HISTORIC AND DESIGN REVIEW COMMISSION

February 07, 2018

HDRC CASE NO: 2018-003
ADDRESS: 1201 N ST MARYS
LEGAL DESCRIPTION: NCB 835 BLK 15 SW IRR 68.3 FT OF A2 FORM SW IRR 70.4 FT OF A2
ZONING: FBZ SD,HE
CITY COUNCIL DIST.: 1
LANDMARK: Commercial Building
APPLICANT: Benito Polendo
OWNER: Luis Oseguera Kernion
TYPE OF WORK: Exterior modifications, construction of an addition, hardscaping
APPLICATION RECEIVED: December 22, 2017
60-DAY REVIEW: February 20, 2018
REQUEST:

The applicant is requesting a Certificate of Appropriateness to:

1 ROOF PLAN - NEW WORK

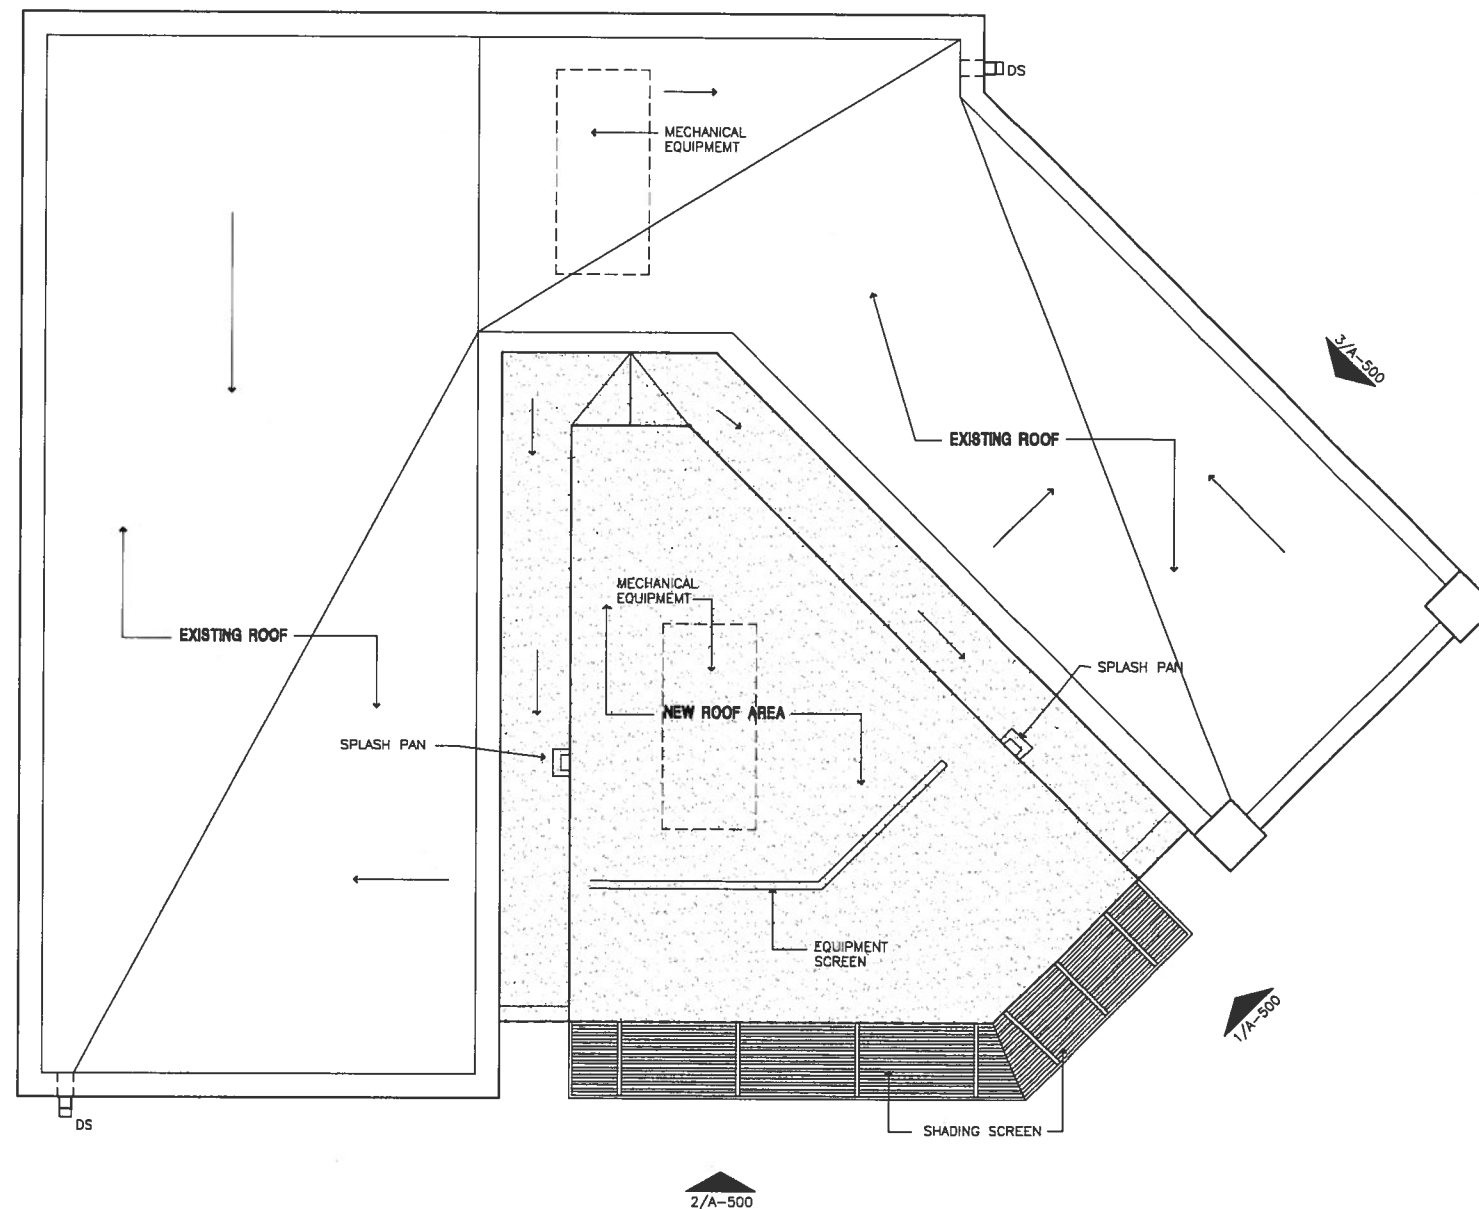
- j. **MECHANICAL EQUIPMENT** – The proposal includes a new mechanical equipment screen near the center of the addition's roof. The screen will be set back from the primary façade by approximately eight feet. The screen will be several feet in height and be the tallest element of the structure. The screen features the same concrete plaster finish and parapet detailing as the rest of the proposal. While the screening approach is generally consistent with the Guidelines, staff finds that the applicant should make every effort to reduce the height of the screen to minimize its prominence as a building feature.

- 4. That the applicant reduces the height of the rooftop mechanical screen where feasible and provides a line of sight study that illustrates its visibility from the street as noted in finding j. The applicant should also consider concentrating the mechanical systems on the existing historic structure's roof to help reduce the impact of the addition on the west façade.

Screen falls back: ok if it's 8' +.

1 BUILDING ELEVATION
SCALE: 1/4"=1'-0" LOOKING EAST

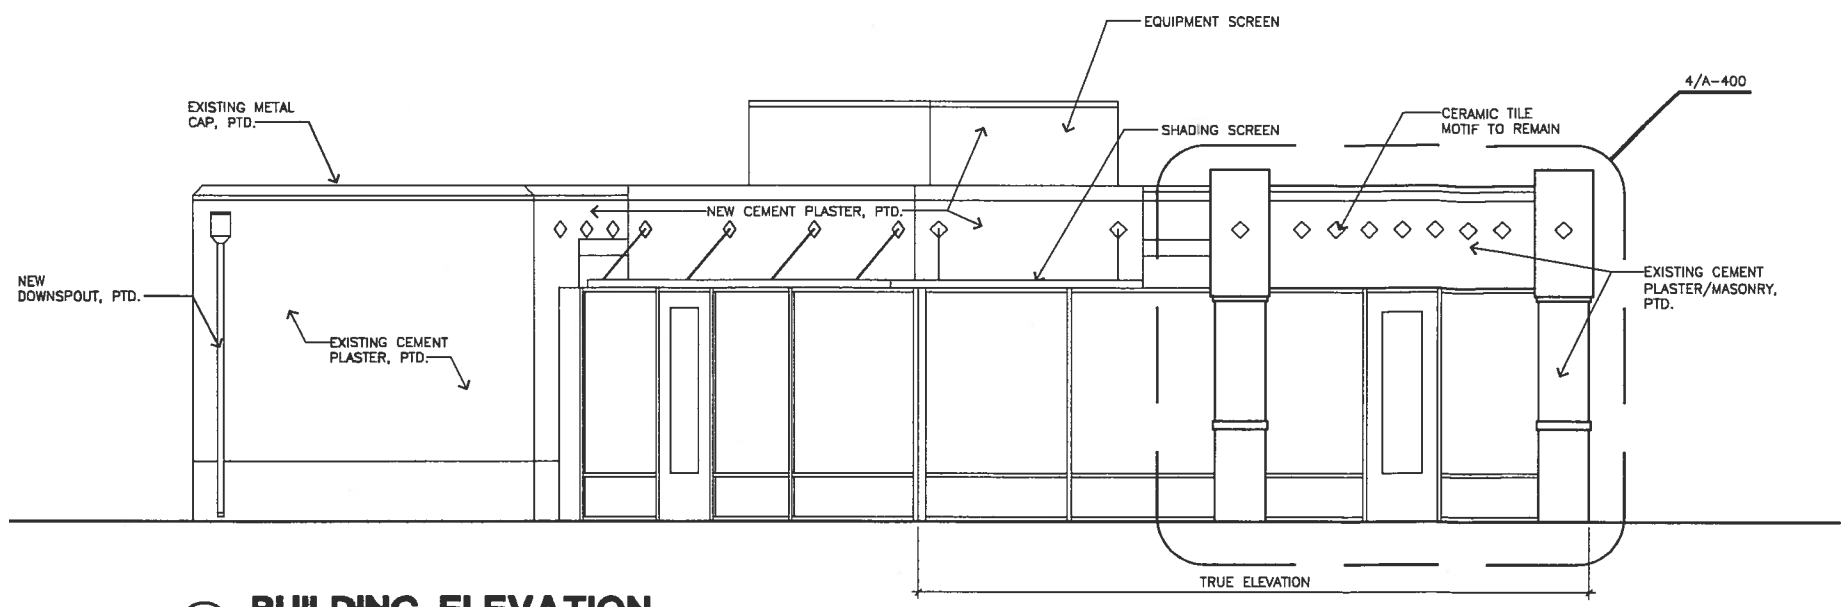
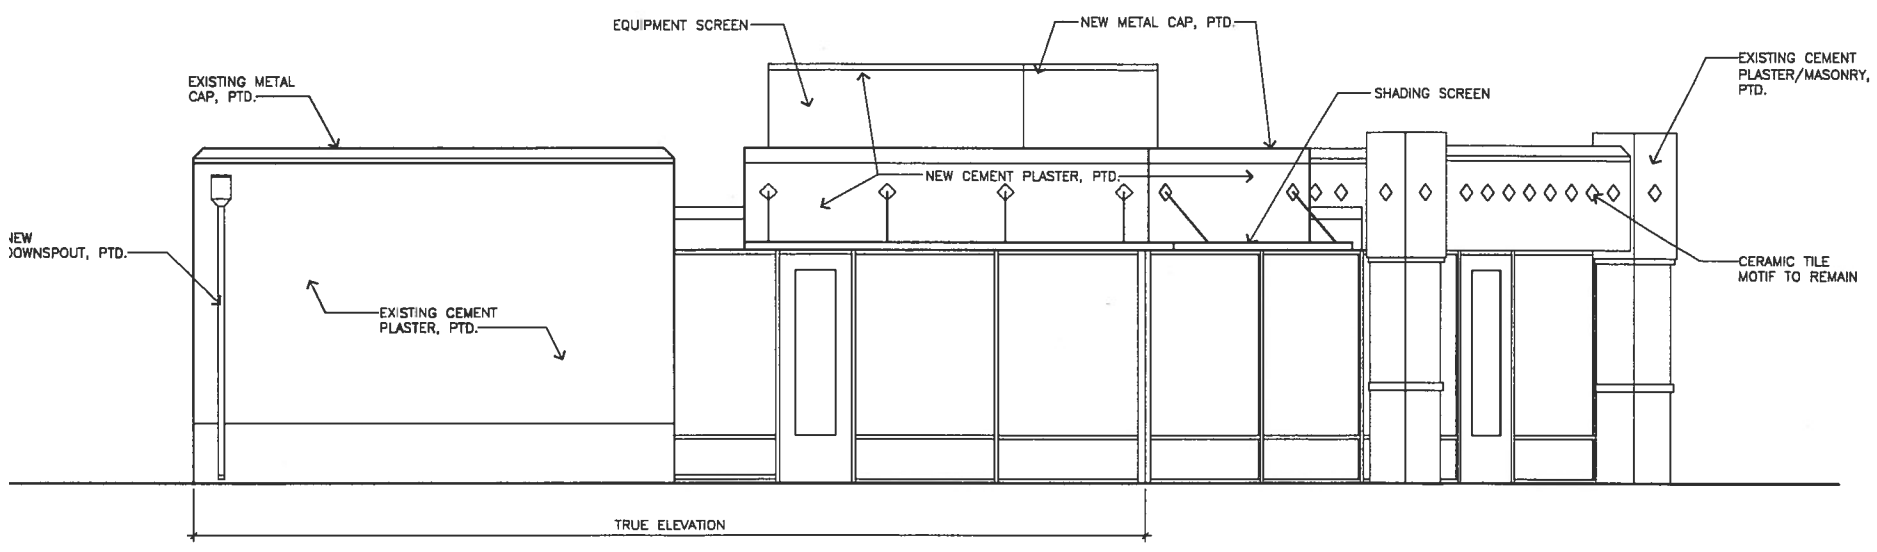
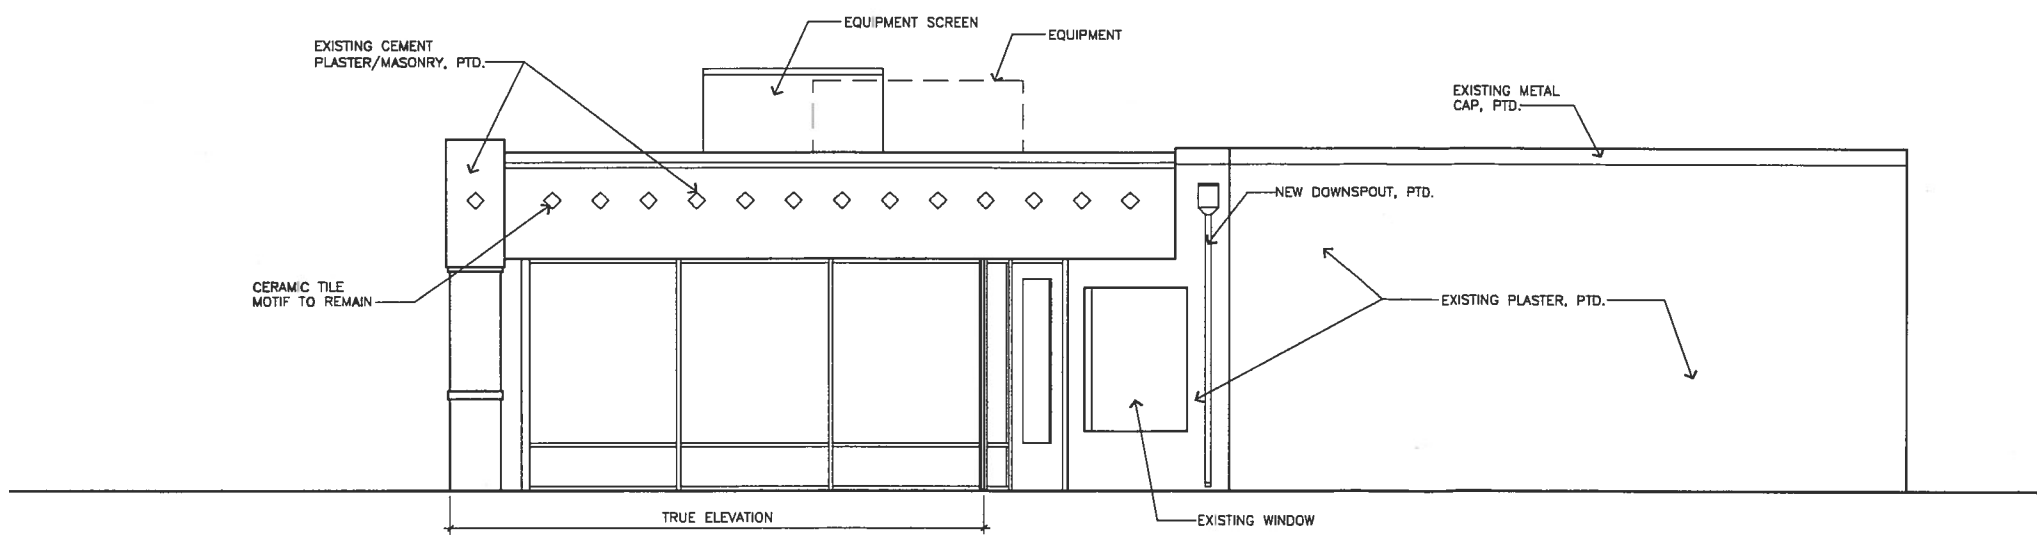
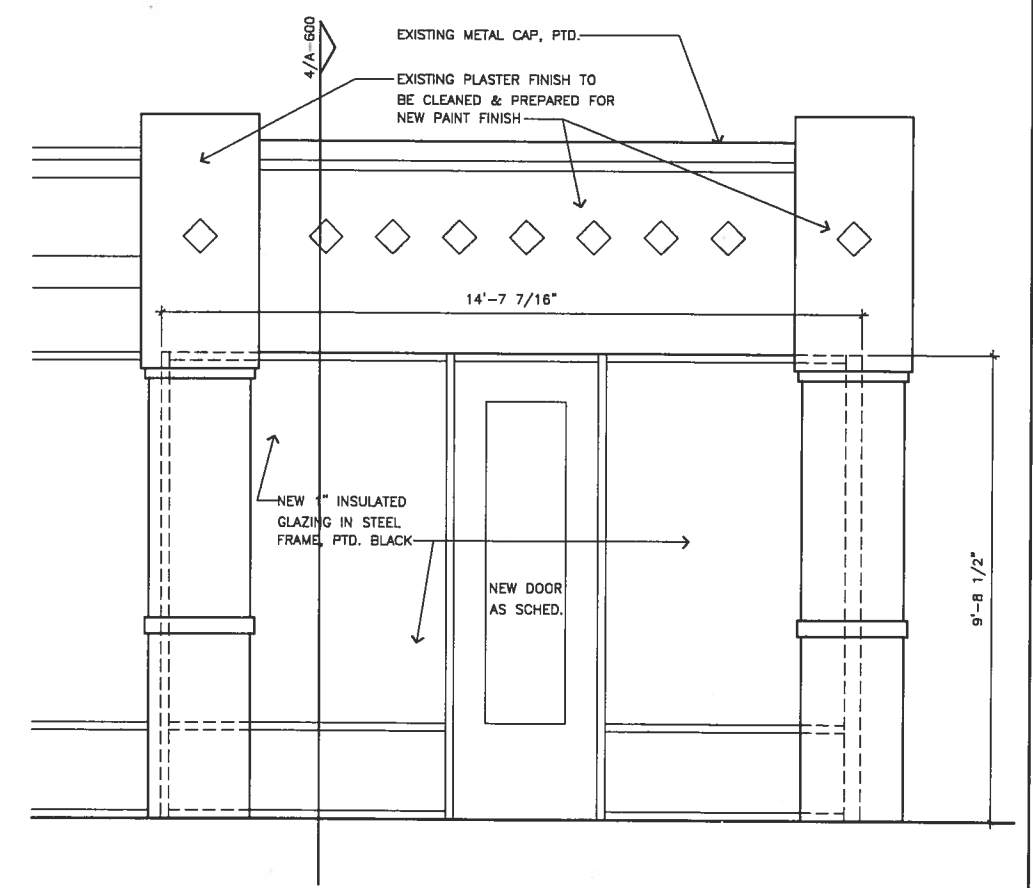
- c. **MASSING AND FOOTPRINT** – The applicant has proposed to construct an addition to the primary structure. The existing structure measures approximately 1,110 square feet. According to the Historic Design Guidelines, additions should not double the size of the primary structure and should be subordinate to the existing structure. The proposed addition measures 900 square feet. This approximately doubles the size of the primary structure. However, the historic structure has a small footprint, and the location of the addition incorporates the existing service bay canopy. Staff finds the footprint generally acceptable given the specific design considerations of the structure, but finds that the west wall parapet detailing should distinguish itself from the historic structure in terms of materiality, height, and detailing. Currently, the proposal incorporates the same façade material and elevated diamond detailing to mimic the existing structure. Staff finds that the material and detail treatment of this addition should be distinguished as new to the historic fabric of the site. The overall height of the addition should also be reduced in order to avoid damage and concealment of the original decorative portions of the canopy.

- d. **ROOF** – The historic structure features a flat roof with a raised parapet. The proposed addition also features a flat roof with parapet detailing. The proposed height matches that of the existing structure. The Historic Design Guidelines for Additions state that new additions should utilize a similar roof pitch, form, and orientation as the principal structure. The addition should be subordinate to the primary structure and should never be so contrasting as to overwhelm or distract from the existing structure. Staff finds that the roof's mimicry of the historic structure in terms of its material treatment and parapet detailing is not consistent with the Guidelines regarding distinguishing additions as new. Staff finds that eliminating the parapet or proposing an alternative roof form would be more consistent with the Guidelines.

canopy is generally appropriate to distinguish the original structure from the addition in terms of materiality and transparency, but finds the use of cement plaster above the storefront should be reconsidered. Due to the placement and high visibility of the proposed addition, staff finds that an alternative material would be more appropriate and help the addition to appear subordinate to the original canopy and service bays. As noted in finding c, the overall height of the addition should also be reduced in order to avoid damage and concealment of the original decorative portions of the canopy. As noted in finding d, staff finds that eliminating the parapet or proposing an alternative roof form would be more consistent with the Guidelines.

- i. **TRANSITIONS BETWEEN OLD AND NEW** – As noted in finding h, the addition will incorporate cement plaster detailing above storefront windows and doors. According to Guideline 2.A.v for Additions, additions should provide a clear visual distinction between old and new building forms through materials and design details. Staff finds that the proposal as submitted does not clearly distinguish the addition from the historic structure. A change in materials would be more consistent with the guidelines.

- 1. That the applicant reduces the overall height of the addition in order to avoid damage and concealment of the original decorative portions of the canopy as noted in findings c and h.

- 2. That the applicant eliminates the parapet detailing on the addition or proposes an alternative roof form as noted in findings d and h.
- 3. That the applicant utilizes a more transparent material and design approach to the addition, particularly the west elevation, to avoid obscuring the character defining features of the historic structure as noted in findings c, d, h, and k.

Difference between new and existing is 30". Poot out
4'.

Thin out the height, the edge. In line with height
would be an improvement. →

Second part: elevation is flush, ~~to~~ should be set back.

think of it as "picture frame" for shading. Consider pushing it back.

DOOR # 112

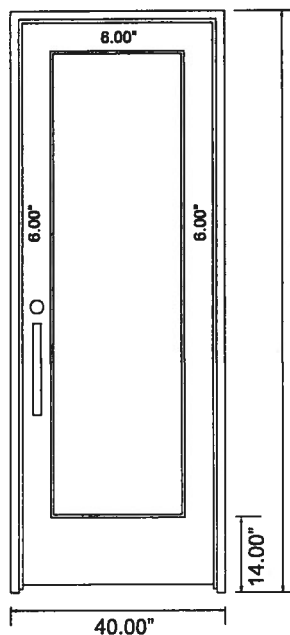
AMS TO PROVIDE BETTER
HANDLE DETAILS WITH
DIMS. TYP. ALL PAGES.

ARCHITECT
PLEASE
CONFIRM THIS
TO BE 84\"/>
